IREDELL COUNTY HEALTH DEPARTMENT

IMPROVEMENT PERMIT / AUTHORIZATION TO CONSTRUCT / OPERATION PERMIT / EXISTING SYSTEM INSPECTION

SUBDIVISION The Point BLOCK / SECTION 13 LOT 137B LOT AREA 1.021 Ac SITE CLASS. 15 DESIGN FLOW 460 gpd L.T.A.R. e 2

INITIAL SITE SKETCH

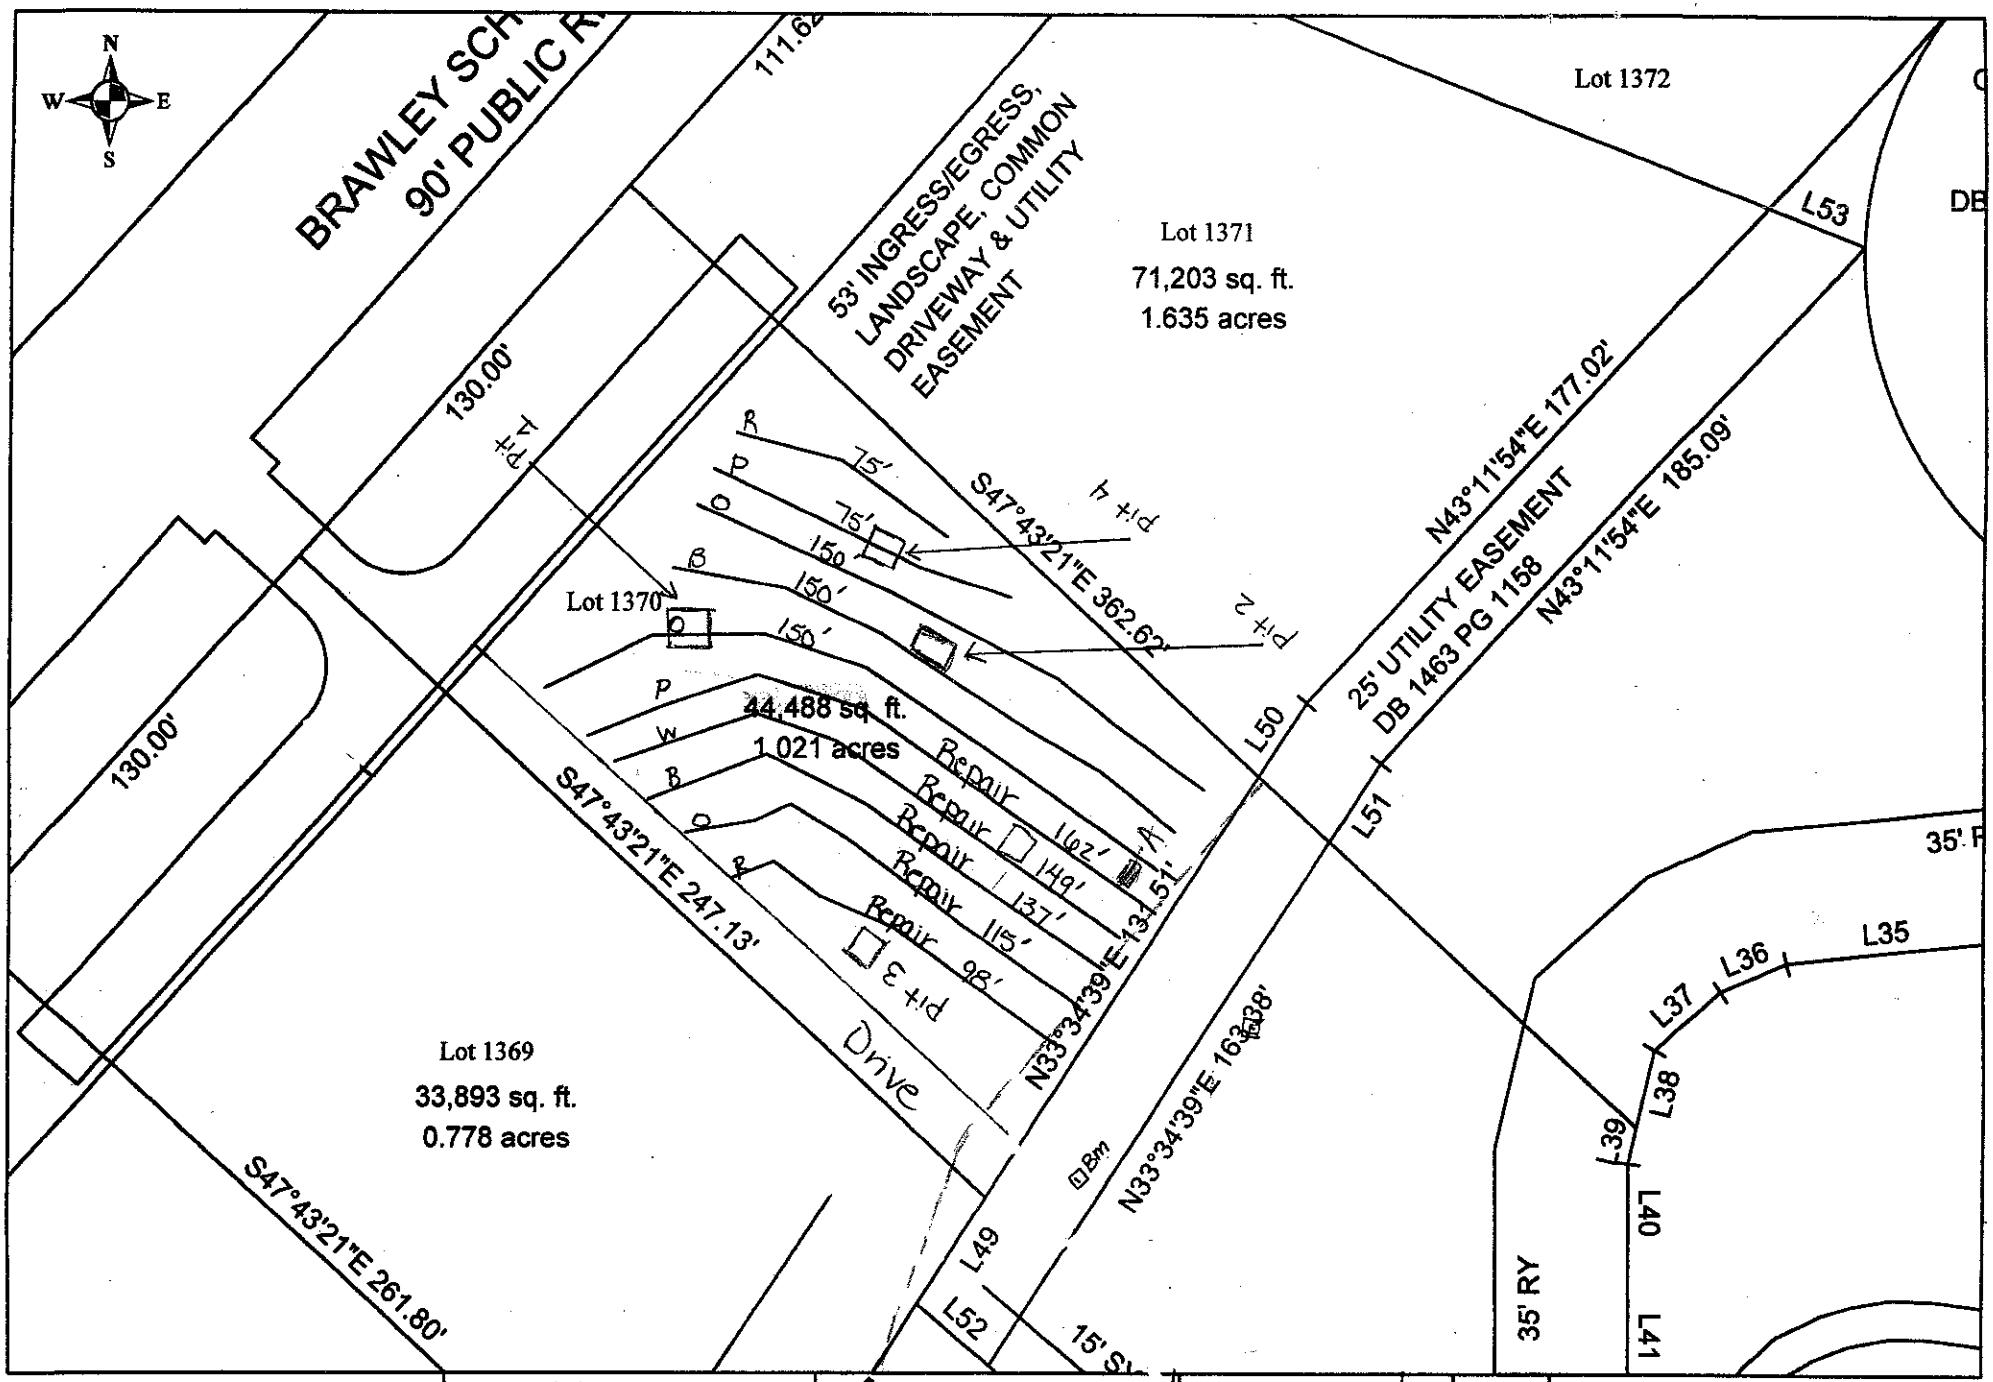
Comments/Conditions: Wastewater supply line must cross underneath water line with 18" min separation. Installer note MAX for each bottom depth. Initial site exploration and layout performed by Paul Baumgarten and Kathleen Hayes of S&ME

Comments/Conditions: System operator to be on site during system construction to verify removal of former drip irrigation pipes, tank with lid and solid pipe if needed as per the plans.

The proposed / existing Pool addition does not appear to impact the existing septic system.

**NOTE: Must be min 15' from septic
